Southern Nuclear Operating Company
Vogtle Electric Generating Plant Units 3 and 4
Request for License Amendment:
Classification of Nonsafety-Related Instrumentation (LAR-16-029)

Vogtle Electric Generating Plant (VEGP) Units 3 and 4

Classification of Nonsafety-Related Instrumentation

(LAR-16-029)

Figure 1: Safety Classification of Instrumentation Sensing Line, Manifold, and Instrument

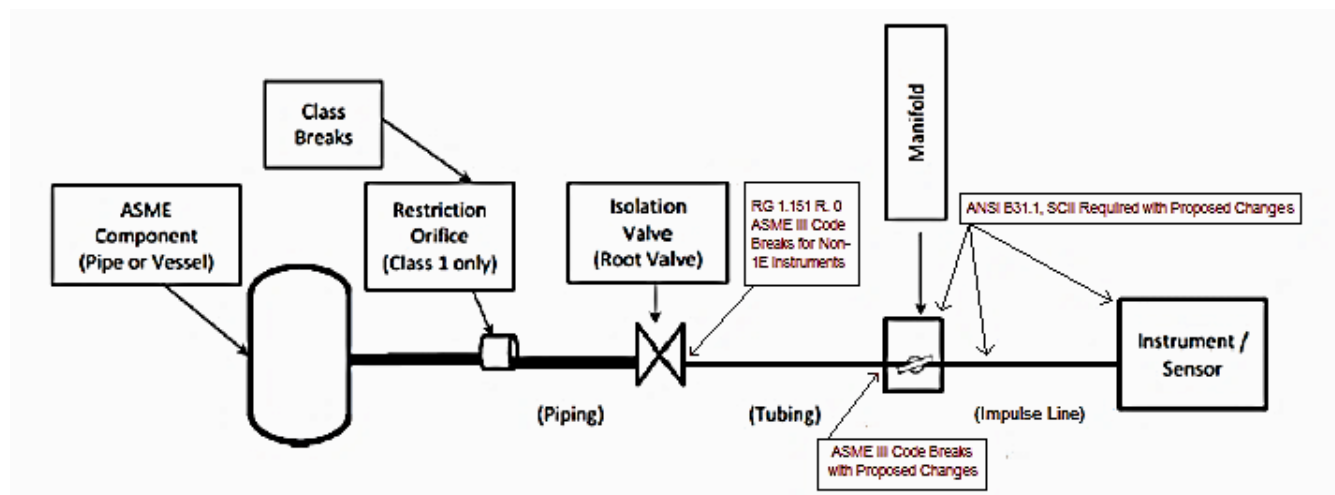
safety-related, seismic Category I. The equipment class applied to the safety-related portions is proposed to be the same as that of the monitored system, which is the same approach applied to safety-related instruments. The proposed changes are shown in the highlighted portion of Figure 1 below.

Note: Section in red border reflects proposed changes, other sections are consistent with current classification methodology.

Plant-Specific Change	Description of Proposed Change
UFSAR Section 3.2.2.8	Revise to state that for nonsafety-related instruments interfacing with safety-related pressure boundaries, the instrument sensing lines and isolation valves have safety-related pressure boundary function, and the instrument manifold, sensor and impulse line are nonsafety-related and seismic Category II.
